TWEED
SHIRE COUNCIL

7 December 2017

NWS LICENCE APPLICATION UNDER THE WATER INDUSTRY COMPETITION ACT 2006 (NSW) FOR THE KINGS FOREST DEVELOPMENT - TWEED SHIRE COUNCIL SUBMISSION

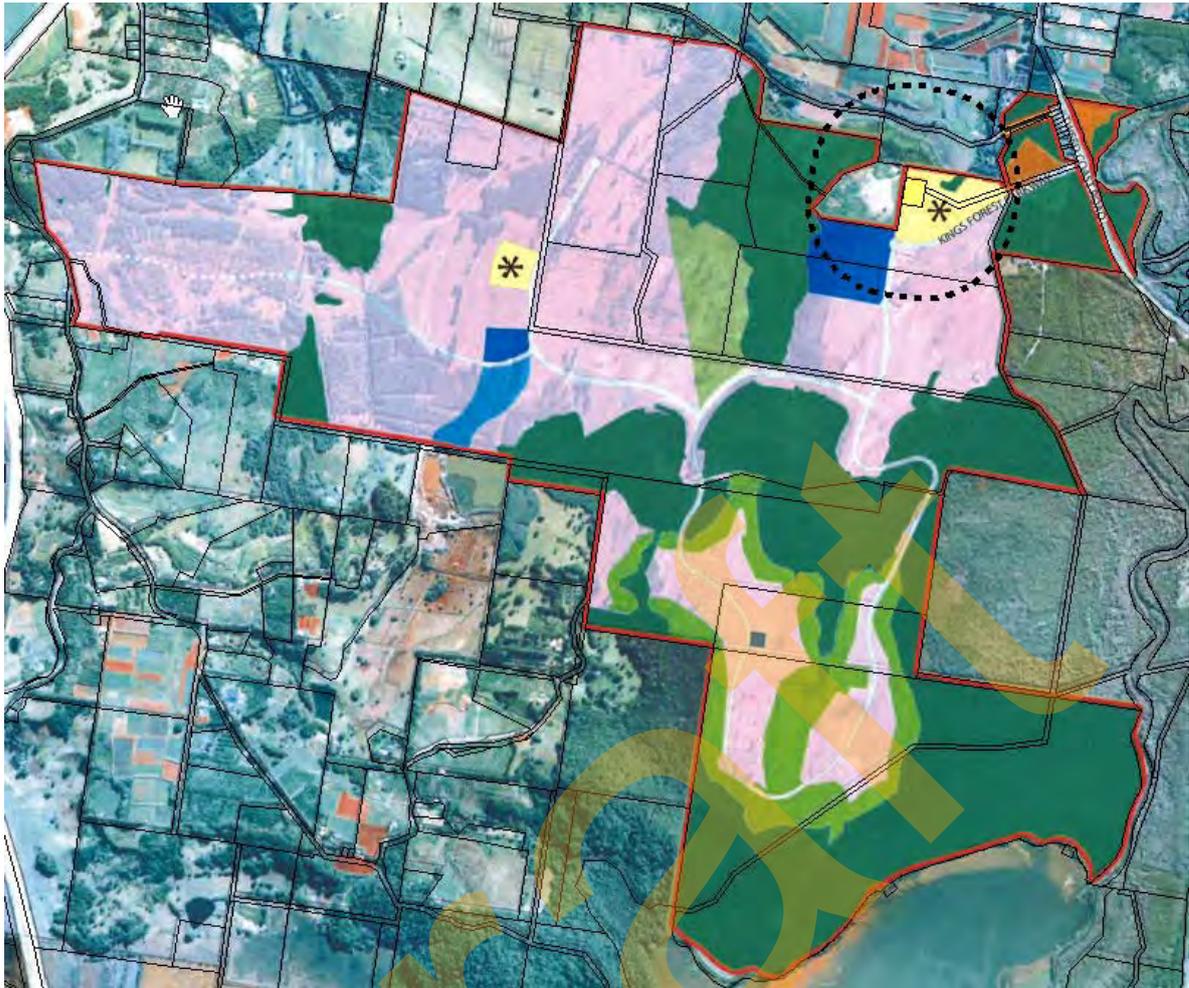
Concerns:

- The consultant has used a repealed version of the NSW EPA's Approved Methods for the Modelling and Assessment of Air Pollutants in New South Wales. The latest version should be used.

- Consultant may consider the draft NSW Best Practice Odour Guideline (NSW Department of Planning, April 2010).
- Confirmation that odour management includes aerosols or potentially toxic air pollutants.

- Location of the WWTP appears to be closer to the existing receivers in Secret Lane (250m) as shown within the Odour Report compared to the Supporting Document by Planit.

- Proposed Maintenance and Site Management Plan for construction and operational phases. The consultant should provide recommendations on options to reduce or eliminate odour impacts.
